Modifications to 130 Euclid Ave.
130 Euclid Ave
Hastings-on-Hudson, NY
10706

STORMWATER MANAGEMENT PLAN & DRAINAGE ANALYSIS

Re: Site Plan Review
130 Euclid Avenue
Owner – Michael Berger & Jonna Rosenberg
Village of Hastings-on-Hudson, NY

Project: Modifications to 130 Euclid Avenue

Pond 3P: 6 CULtec 330XL Units

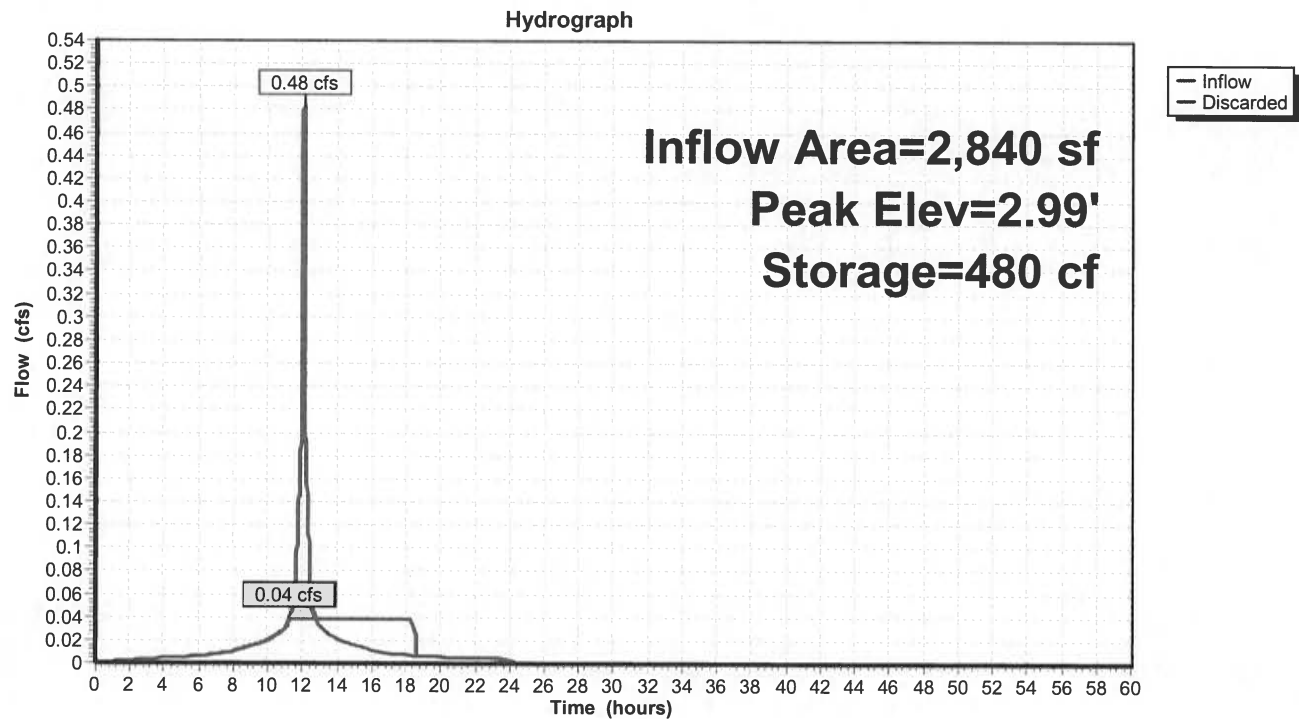
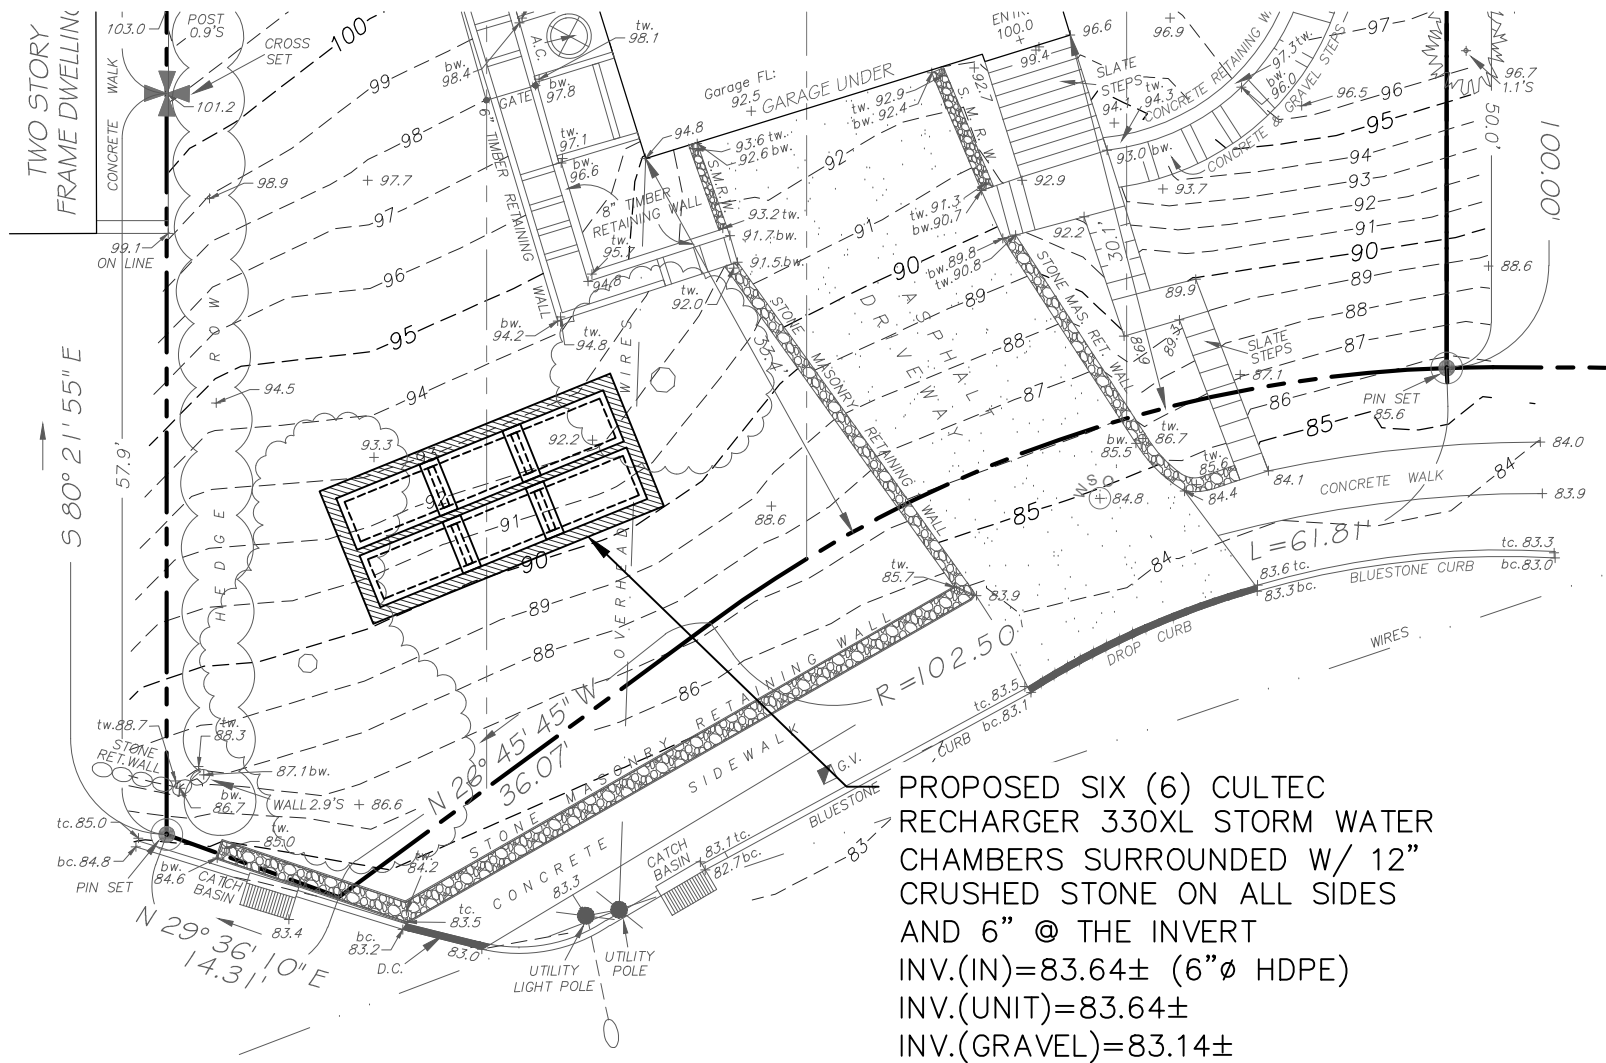
In turn, a bigger footprint would result in a greater depth being required. The Planning Board specifically requested we protect existing trees to the maximum extent possible. An infiltration system would very likely result in excavating the roots in close vicinity to any potential system as shown in the attached sketch. The system would also require more disturbances to steep slope areas contrary to the purview of work in steep slopes.

- 3.) Comment noted. Future testing will strictly follow NYSDEC standards. An infiltration is not proposed to be utilized.
- 4.) A nyloplast basin is proposed as a control structure on sheet C-1 and detailed on sheet C-2.
- 5.) The mini channel drain detail refers to the drains abutting the rear walls to collect patio runoff.
- 6.) Comment noted. The verbiage has been revised.
